Project	IEEE 802.16 Broadband Wireless Access Working Group < http://ieee802.org/16 >	
Title	Slave Hierarchy for Better Usage of Regions not Interfered by the Master Subframe	
Date Submitted	2007-01-08	
Source(s)	Avi Freedman Hexagon	Voice: +972-3-9224420 Fax: +972-3-9223596 Email: avif@hexagonltd.com
Re:	Letter Ballot # 24	
Abstract	Suggestion for improvement of usage of overlapping regions in the ASFA scheme, using slave hierarchy	
Purpose	Improving usage of overlapping regions by introducing priority among slaves in the ASFA algorithm. This priority will allow serving the regions where there is slave coverage overlap, without interference to the master.	
Notice	This document has been prepared to assist IEEE 802.16. It is offered as a basis for discussion and is not binding on the contributing individual(s) or organization(s). The material in this document is subject to change in form and content after further study. The contributor(s) reserve(s) the right to add, amend or withdraw material contained herein.

Slave Hierarchy for Better Usage of Regions not Interfered by the Master Subframe

Figure 3: Regions served during the various subframes

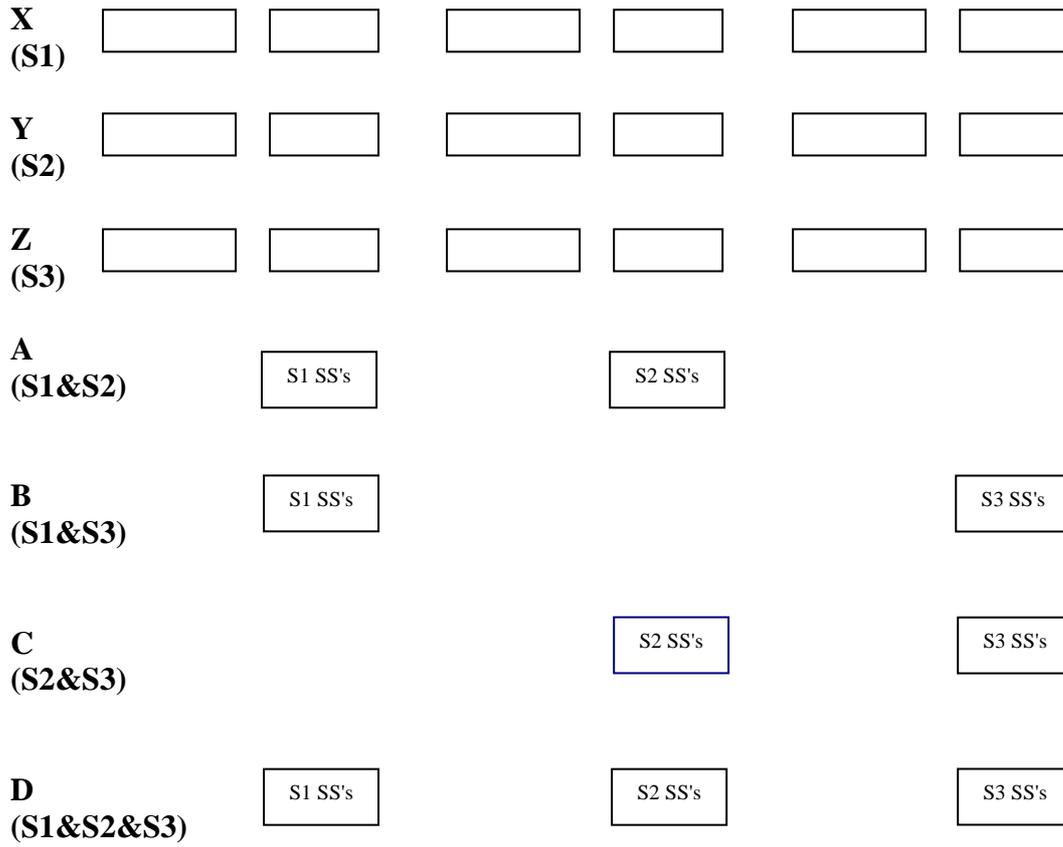
Figure 3 below shows the regions served by the S1, S2 and S3 systems, during the different frames. Region X, which is served by system S1, without any interference from systems S2 and S3, is served during all the subframes, namely an SS located in that region is served during the common frames as well as during the sub frames in which S1 is either a slave, or, of course, a master.

Similarly, SS's located in region Y and Z are also served by either system S2 or S3 during all the subframes.

On the other hand, S1 SS's located in region A suffer from interference from system S2, consequently they are not served during the common sub-frames but only when S1 is the master. When S2 is the master, it serves all its SS's located in region A. But the current scheme does not specify what happens to S1 or S2 SS's of region A when S3 is the master. Without such specification, either both system would refrain from serving region A (although that won't cause any interference to the master, S3) or both systems would try to serve their SS's in that region with the same end result - no service due to interference.

Similarly SS's in zones B and C will be served only during the master subframes of their corresponding system.

Figure 4: Regions served during the various subframes with slave hierarchy

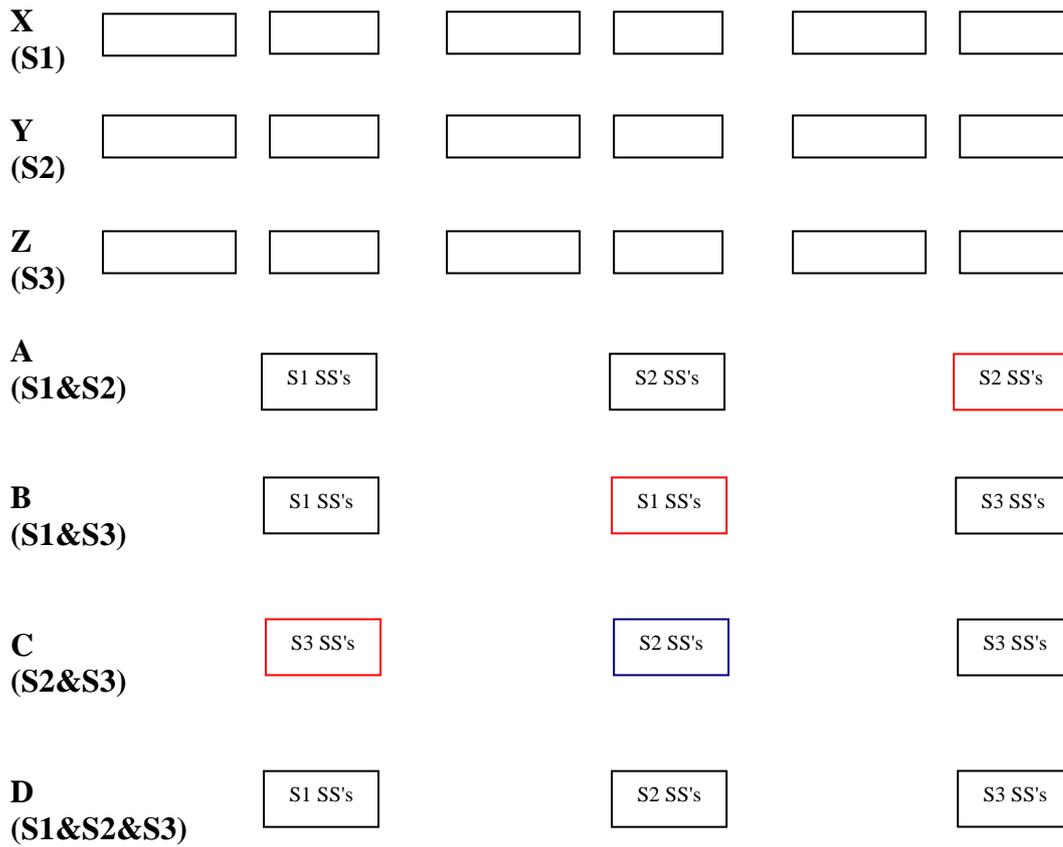
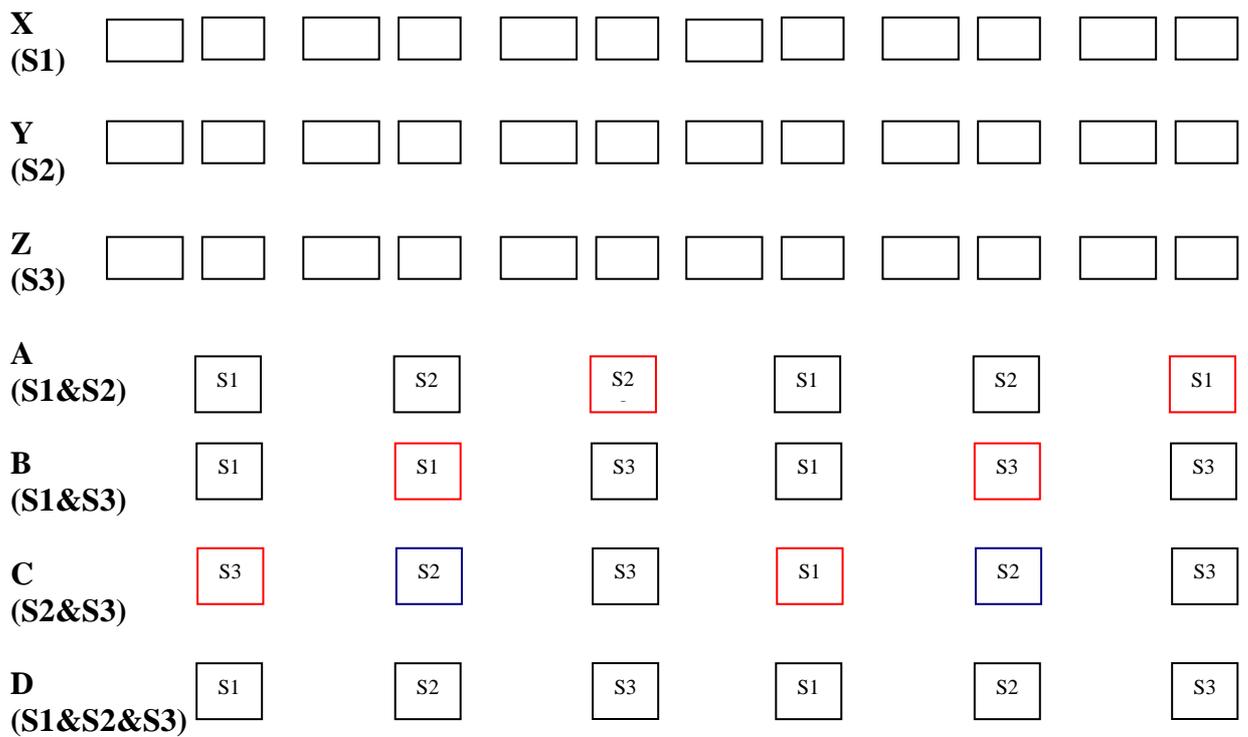
Assume now, that a certain slave hierarchy exists. For example – after being the master a system becomes a "secondary master" and still has priority over all the other systems in the neighborhood but the new master. Thus in the second sub-frame, system S2 is the master, but system S1 is now the "secondary master" and has priority over system S3, in the third subframe, system S3 becomes the master, while system S2, the "secondary master" has priority over system S1, In the fourth subframe, we go back to the structure we have in the first subframe, in which system S1 is the master, while system S3 is the secondary master.. With this scheme the usage pattern will look as described in figure 4. Now during the 3rd subframe, system S2 is the secondary master and has priority over system S1 and the SS's in region A can be served. Similarly S1 SS's in region B will be served during the second sub-frame and S3 SS's in region C will be served during the first subframe. The additional intervals in which a region can be served is depicted by the red rectangles.

A more complex slave hierarchy scheme, when we look at 2 cycles, and change the rule such that in the second cycle, after being the master, a system will have no priority over any other system will allow to serve the SS's in the overlapping regions more fairly, and the usage pattern will be as described in figure 5. In this case, in the first cycle S2 SS's in region A will be served, while during the second one S1 SS's in region A will be served. If there are more than 3 systems in the neighborhood, a more elaborate scheme would be required to allow for fair service in the different regions, however, as it is expected that the number of systems in a community will not exceed 3 (as specified for the type 2 case), and in order to avoid unnecessary complexity, it is recommended that only 2 simple rules will apply.
